Minutes
of
100th PCC Meeting

EASTERN REGIONAL POWER COMMITTEE

MINUTES OF 100TH PROTECTION SUB-COMMITTEE MEETING HELD ON 12.03.2021 AT 10:30 HOURS

A. On 15-02-2021 at 14:30 hrs.

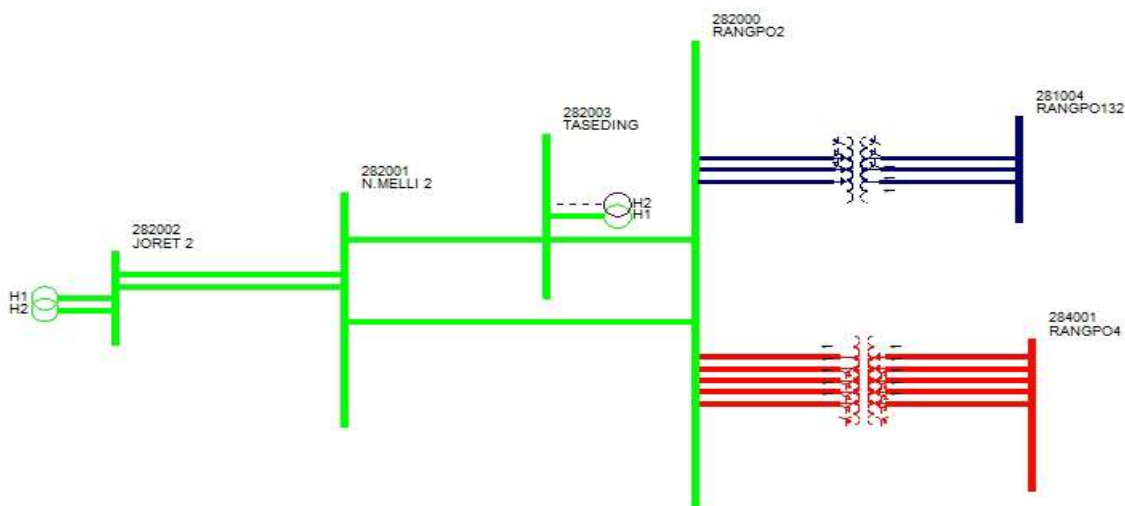
Relay indication has not been captured in both main 1 and main 2 DR recorded at Tashiding end.

- *There was a B-phase to earth fault in 220 kV Tashiding-Rangpo line.*
- *At Rangpo end, the main protection relay initially sensed the fault in zone-3, subsequently it was sensed in zone-2 and the line tripped from Rangpo end in zone-2 timing of distance protection.*
- *As per the relay indication of Tashiding end, there was B-phase to earth fault with maximum fault current of 568 A. There was no indication of zone operation for distance protection as well as no tripping at Tashiding end.*
- *The earthfault relay of Generating Transformer at Tashiding end picked up and tripped after around 1.5 sec of the fault inception resulting in total power failure at 220 kV Tashiding S/s.*
- *On analysis of the settings for GT neutral earth-fault relay, it was found that the settings value is not properly coordinated with that of the lines at Tashiding end.*

After detailed deliberation, PCC advised Tashiding HEP to review the settings of earthfault relay and following settings were recommended:

- *For GT: 160 A with TMS= 0.5*
- *For Lines at Tashiding end: 160 A with TMS=0.4*

PCC also advised to disable the high set operation in GT earthfault relay.

PCC advised Tashiding to check and review the configuration of the disturbance recorders.

(Sr.No 2) LINE VOLTAGE FROM PMU :

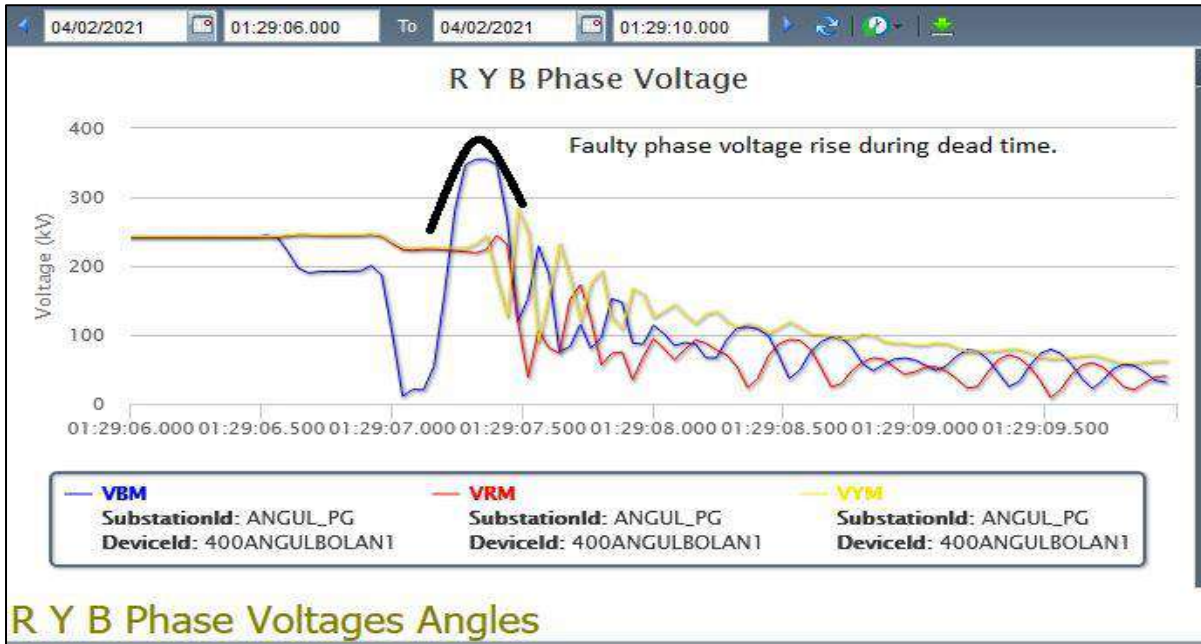
Fault in b phase and ,B pole breaker tripped but during dead time high voltage in B phase observed at bolangir due to secundar arcing which lead to o/v stg-2 operation and line tripping. Reactor tripping scheme implemented at Bolangir to avoid such instances further.

(Sr.No 3) LINE VOLTAGE FROM DR AT MERAMUNDALI END :

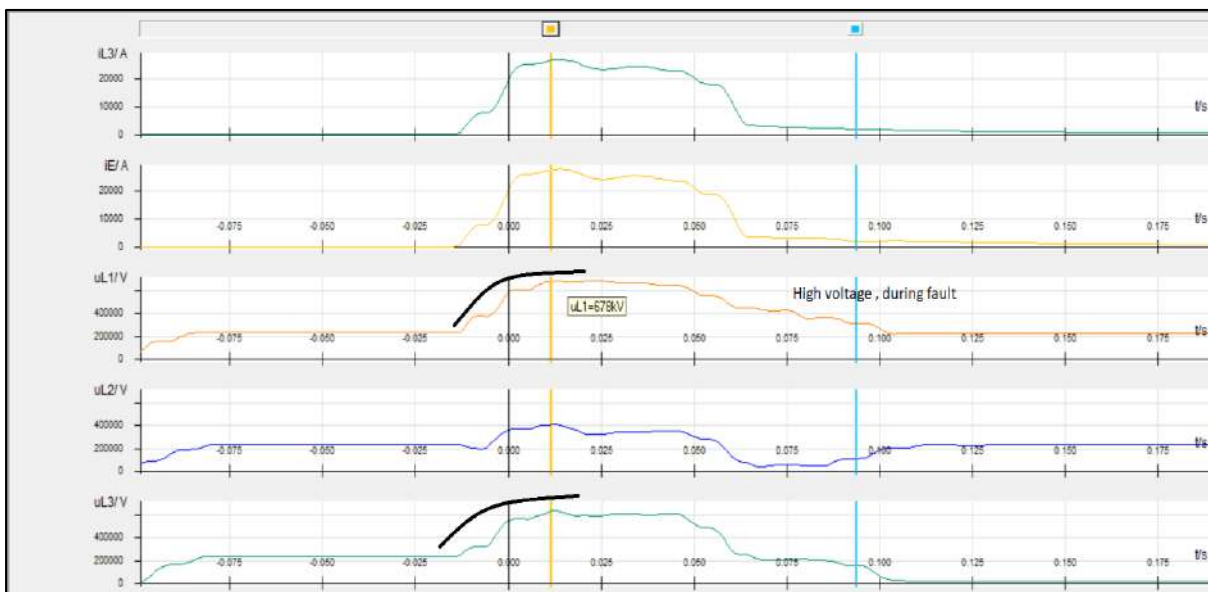
B phase fault ,but ALL three phase voltage increased to a very high value upto 900 kv at the instant of fault .A/R was unsuccessful .Sevier high voltage may cause equipment failure .Earthing needs to be checked and rectified soon.

Sr.No (6) Auto reclose successful from Mendhasal end only ,Line voltage from PMU at Meramundali end.

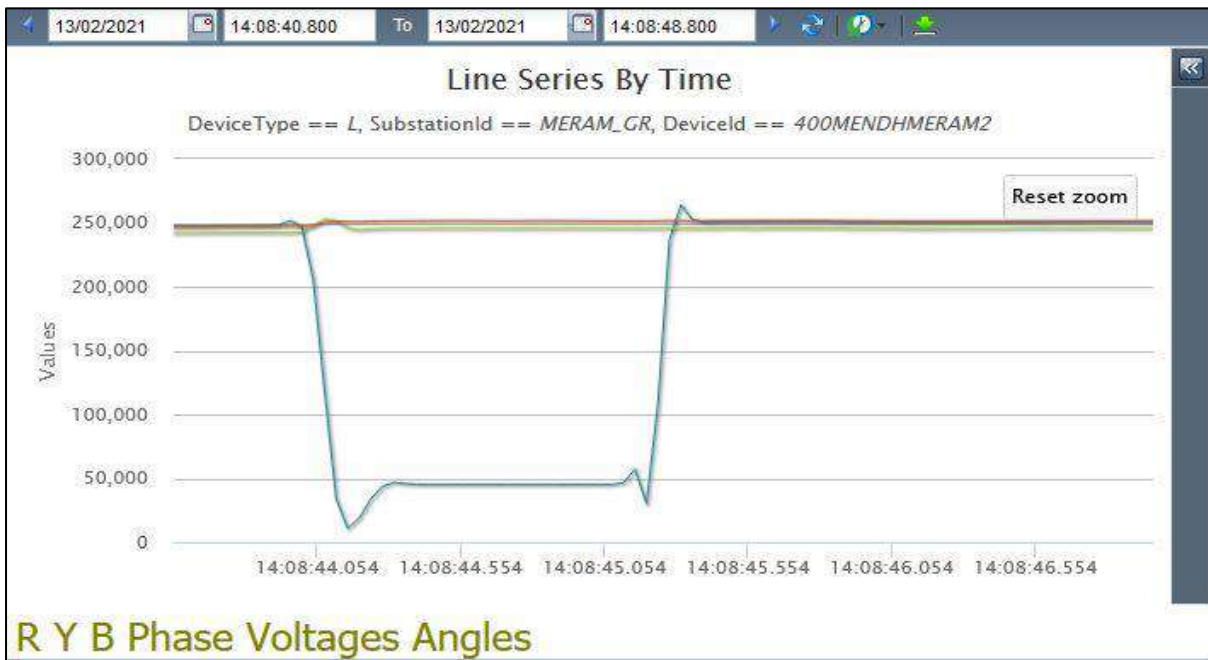
In past also it has been observed that Auto reclose from meramundali is not operating and communication regarding that was already sent in past ,still the same problem is persisting.

Sr.No (9) At Charging Instance ,Line current from PMU

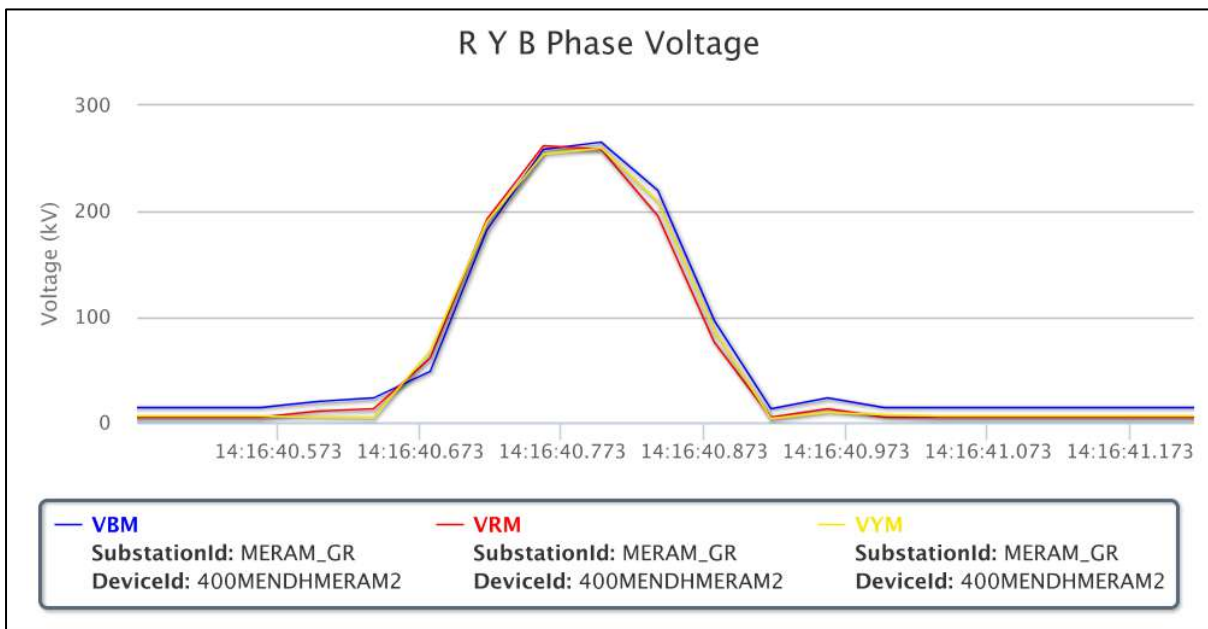
SOTF protection function needs to be checked as it is not fulfilling the purpose of SOTF protection ,as tripping got delayed at charging instance.

Sr.NO(10)

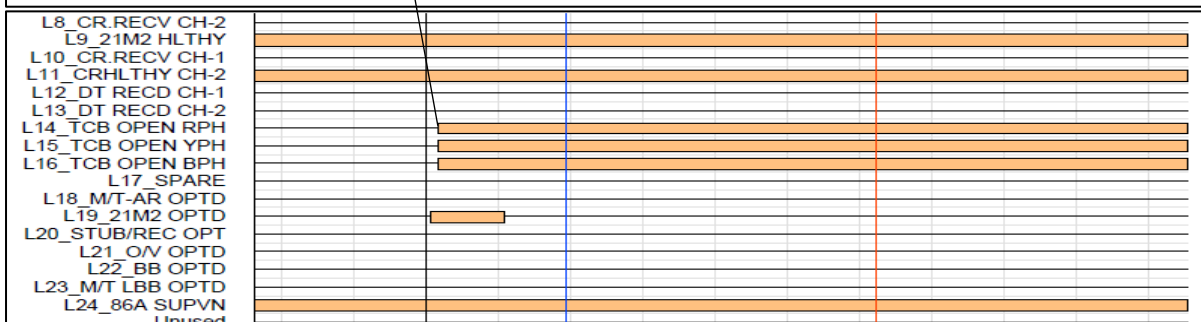
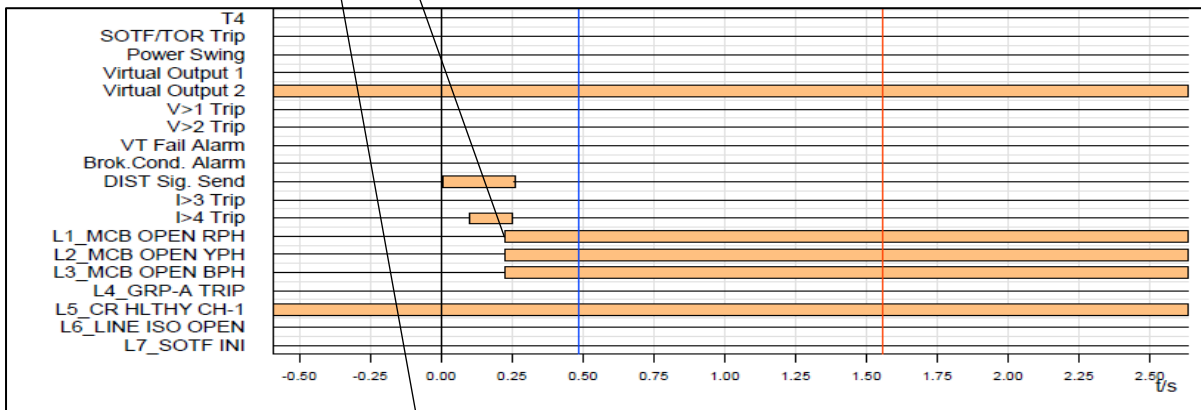
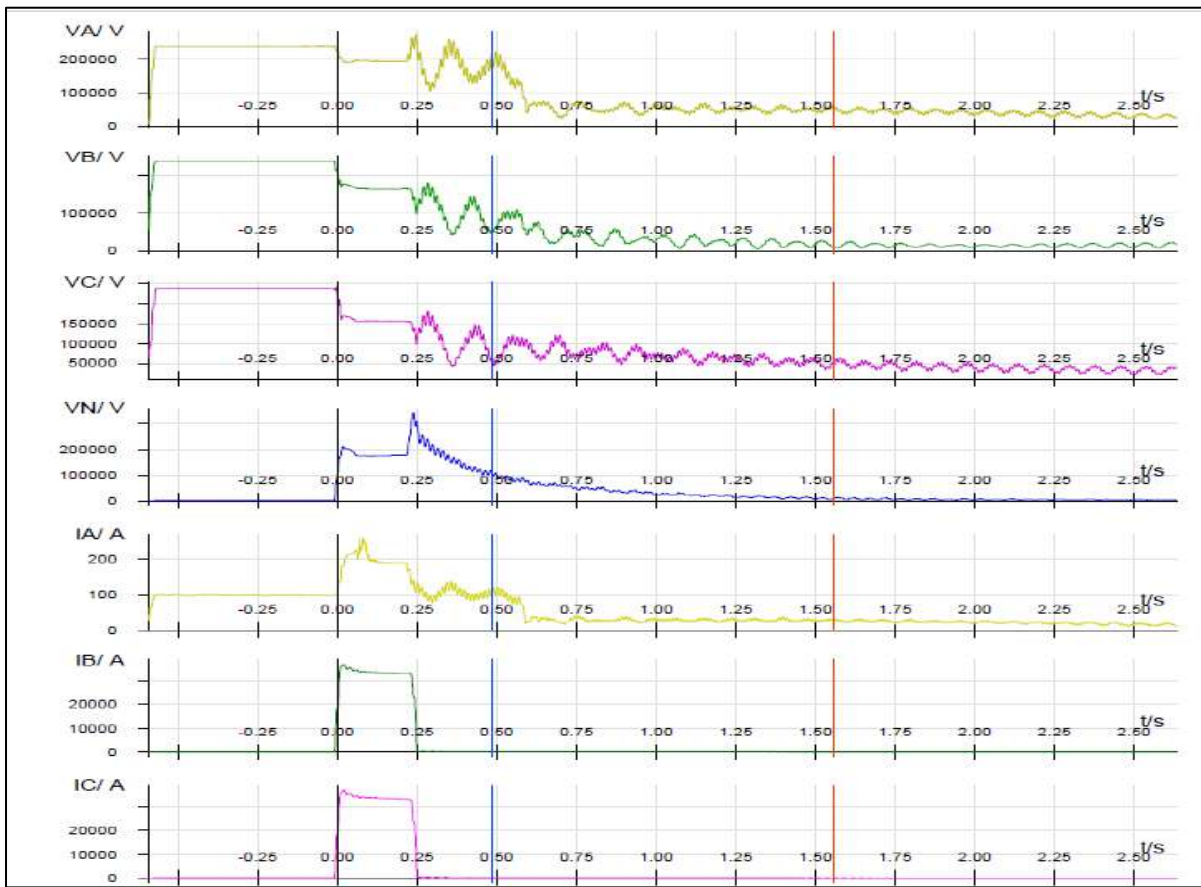
TCB at Lapanga end opened instantly but MCB opened after 200 ms delay which caused fault feeding till 250 ms, although fault was in z-1. This may please be checked .

Regarding delayed tripping of MCB at Lapanga end for fault in 400 kV Meramundali - Lapanga-1 on 27.02.2021, PCC advised to test the main circuit breaker at Lapanga end for 400 kV Meramundali - Lapanga-1.

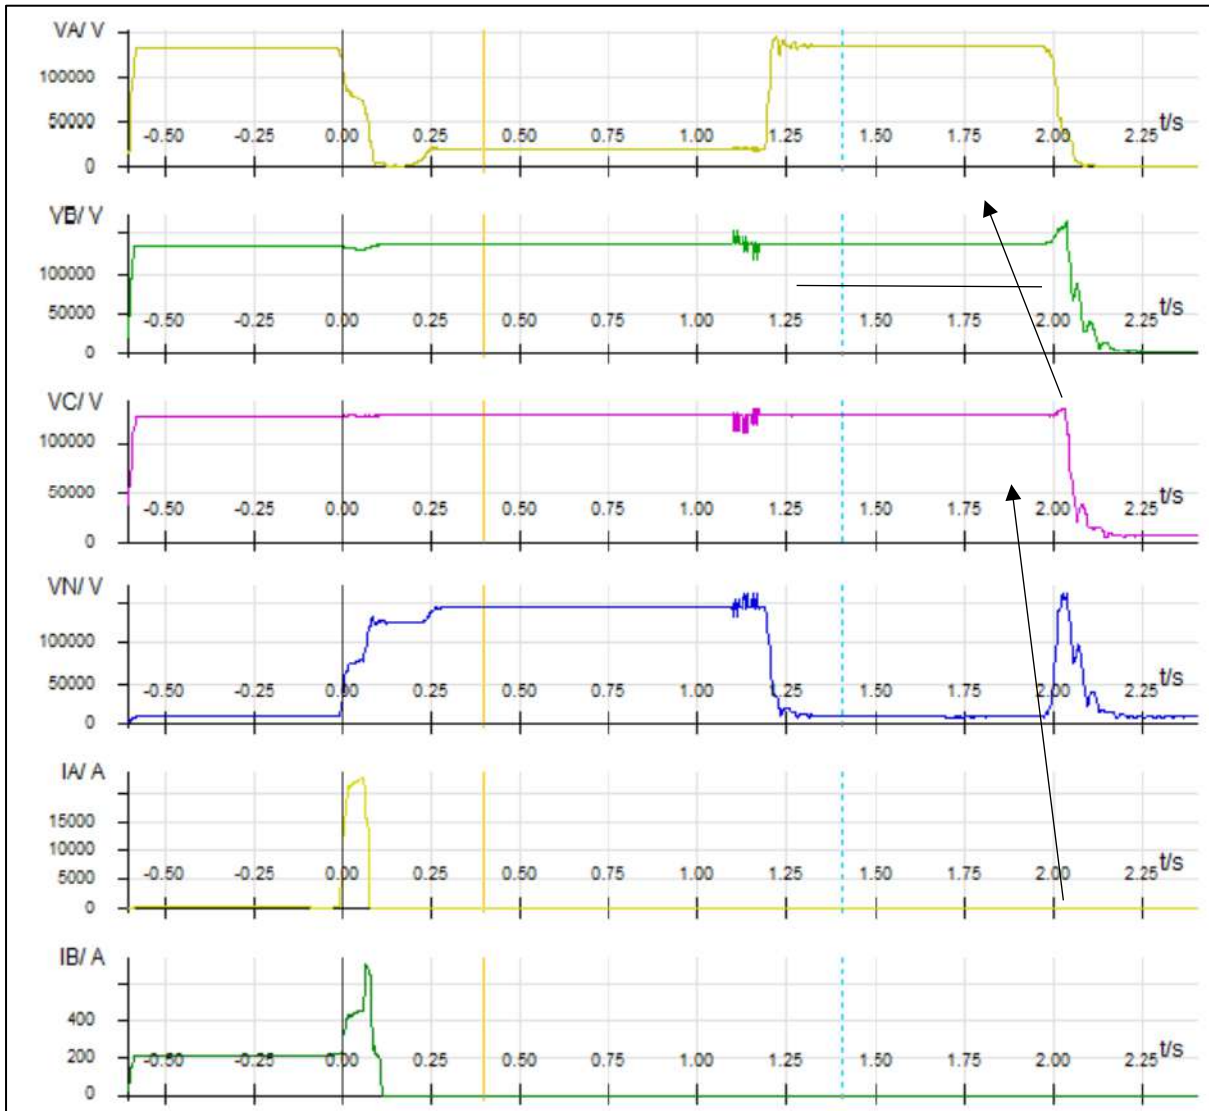
Sr.No(11) From DR it is clear that auto reclose was successful but after 800 ms of successful A/R , line tripped but no fault was noticed .Reason for tripping may be shared.
